Compton Seawall

**APPLICATION FOR SHORELINE SETBACK VARIANCE  
AND  
FINAL ENVIRONMENTAL ASSESSMENT**

**Reconstruction of Seawall**

Compton Property, TMK (1) 6-8-10:25 (Lot 12 )  
68-701 Farrington Highway, Mokuleia, Oahu, Hawaii

Figure 2

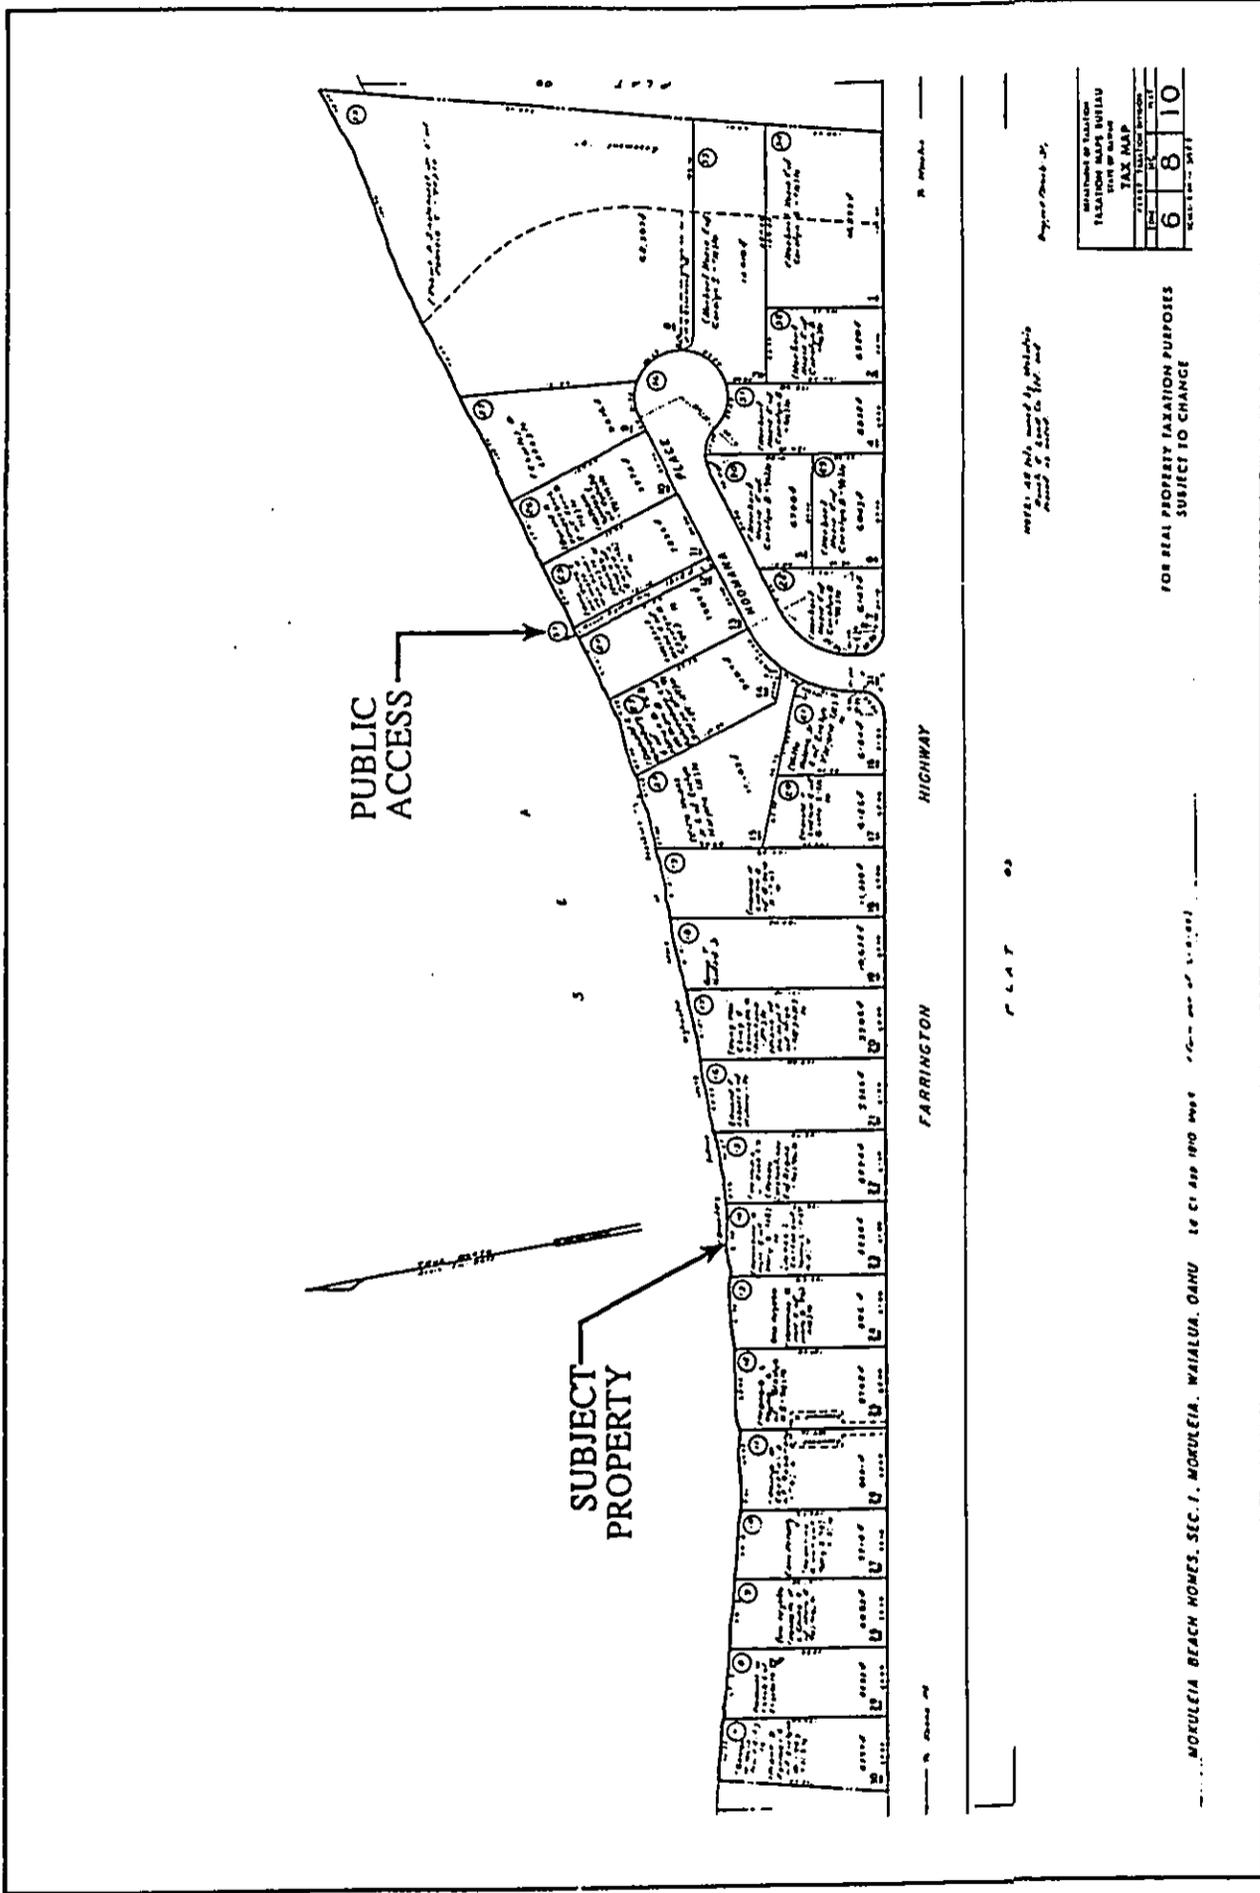
3. Site maps that clearly show the current certified shoreline, previous certified shorelines, the private property line and the location of the proposed structure. Any nearby public access right-of-way should also be depicted.

- 1) **Public Access.** The closest public access right-of-way is depicted in the TMK map shown in Figure 2. An access easement is found approximately 500 feet to the east off Ho'omana Street.

**FIGURE 4**  
**TYPICAL CRM SEAWALL DETAIL**

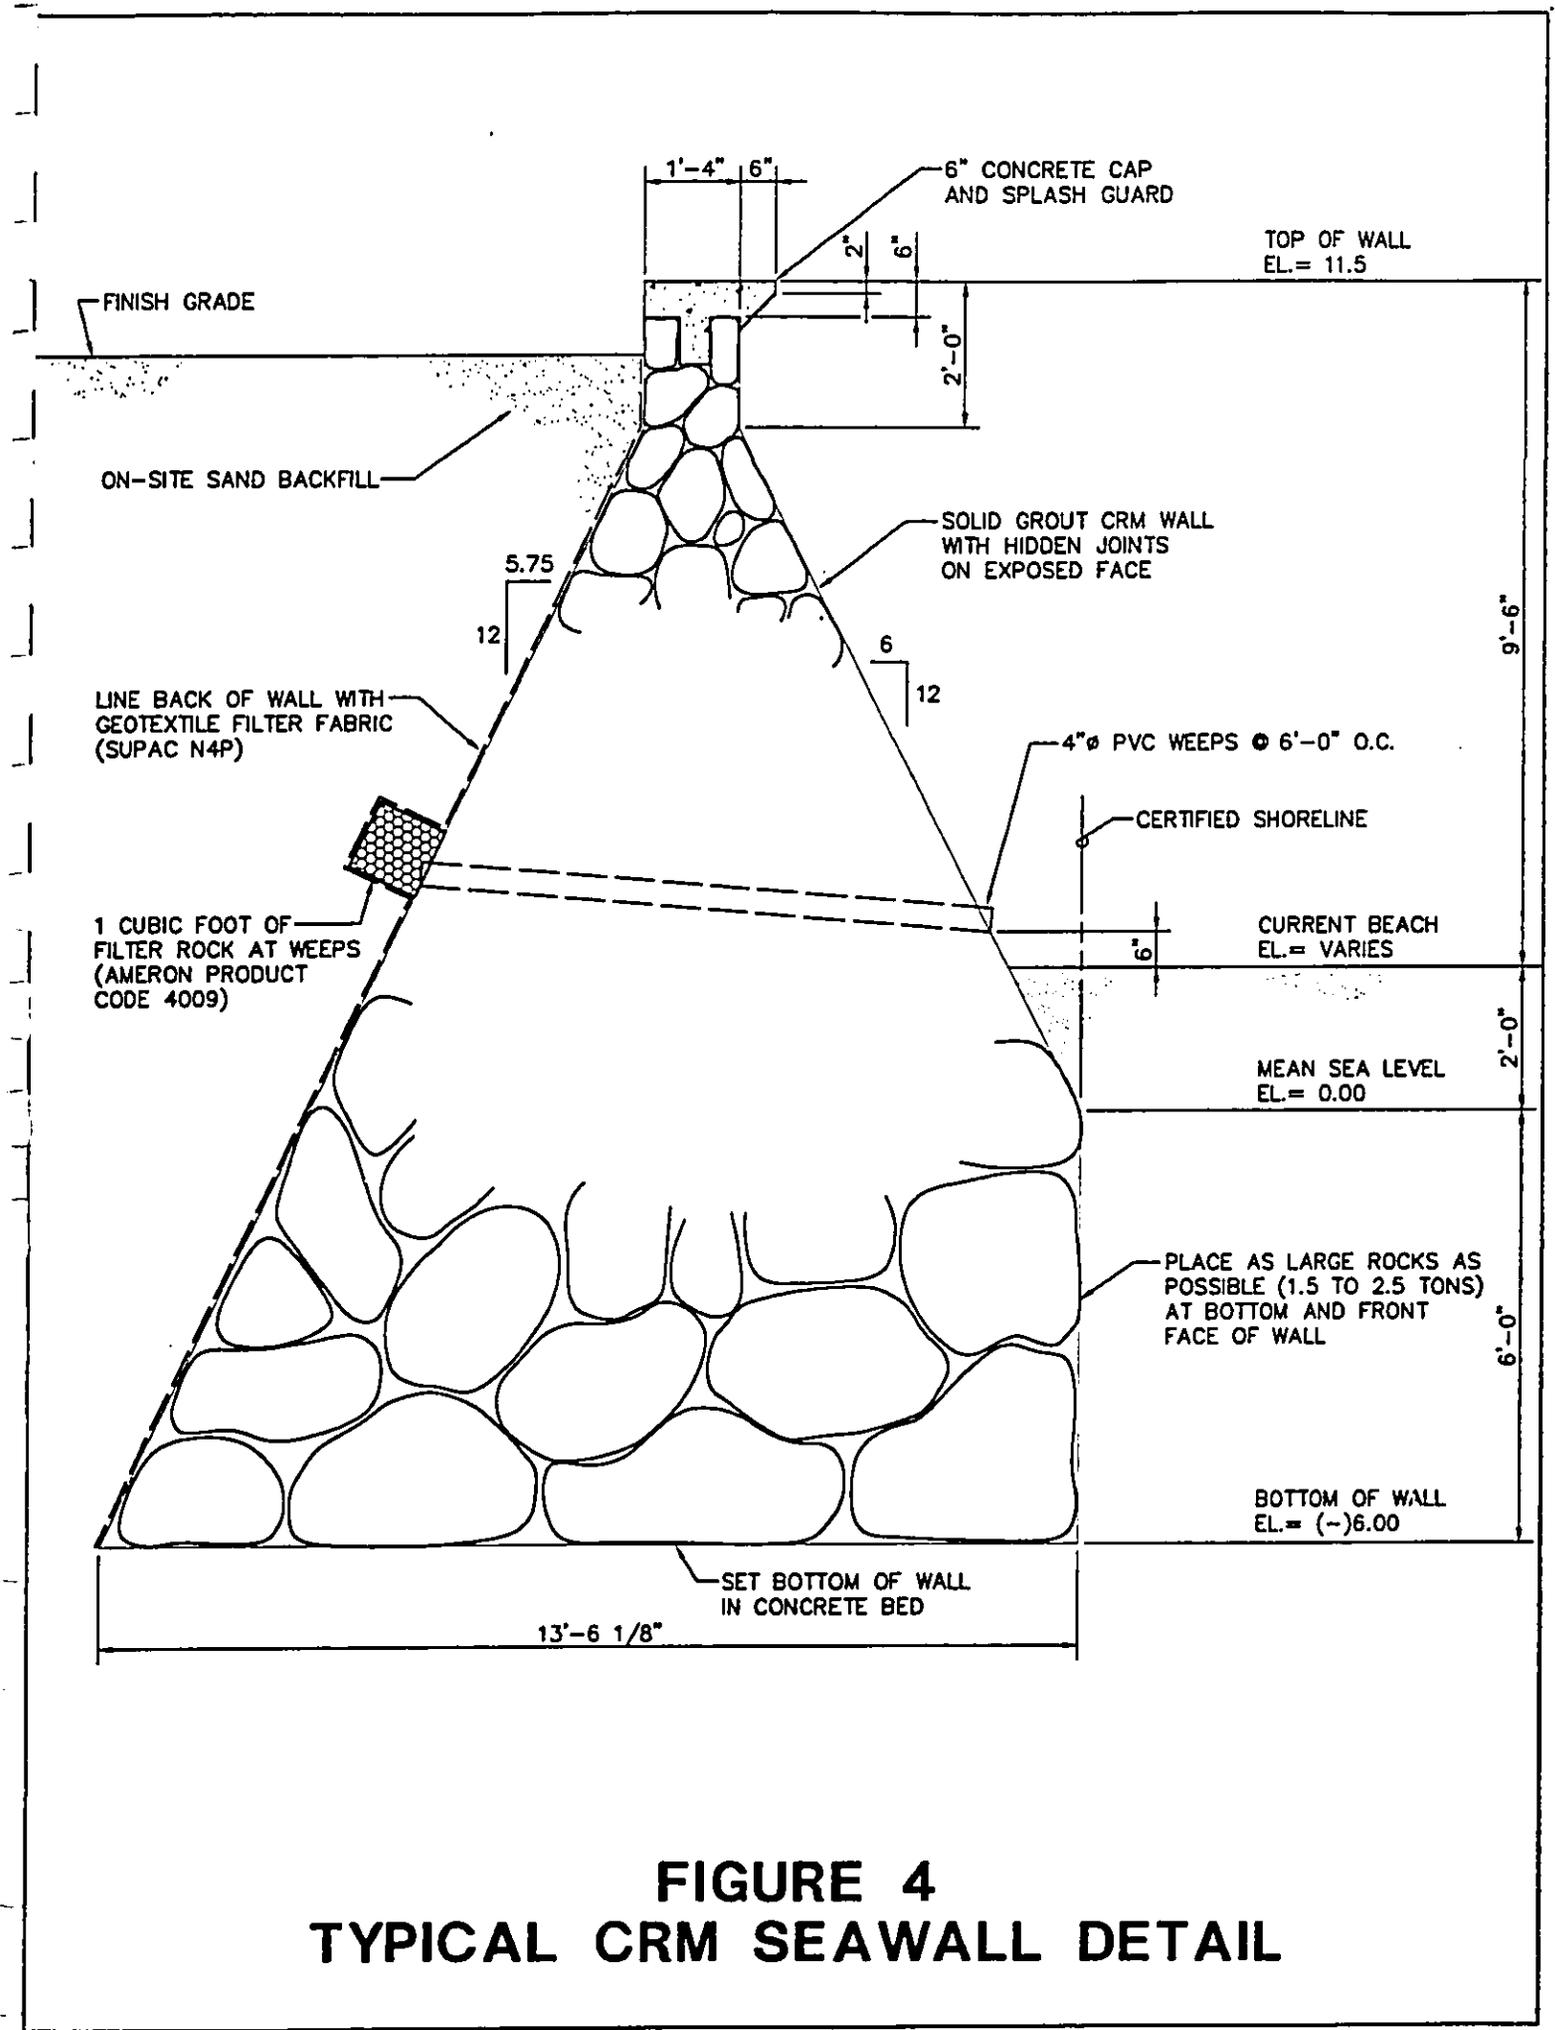
Figure 7 in the DEAs illustrate the design of the proposed seawall structures. The tops of the proposed seawalls are only 1' 10" wide. This hardly seems adequate to allow "safe" lateral access to the shoreline especially during times of high surf events. The proposed seawalls should be designed to allow shoreline access without presenting a safety hazard to the public.

2. **Lateral Shoreline Access.** The four seawalls are aligned together and match the adjoining properties on either side. At this location, there are 16 properties in a row that are all protected by vertical seawalls. The beach along this entire section of the Mokuleia coast could be considered very narrow. Lateral passage along this shoreline in front of the seawalls will be improved by the proposed action, which will remove loose rock debris and deteriorated wall sections, and replace these with an engineered modified vertical seawall structure. With the lower sloped portion consisting of large rock material, there will be a return of a slightly wider beach for lateral passage. At the three lots to the west where modified vertical seawalls were recently built with the hybrid wall design, there has been a recent return of a narrow strip of beach sand along a section where there was no beach sand for lateral passage in the recent past.
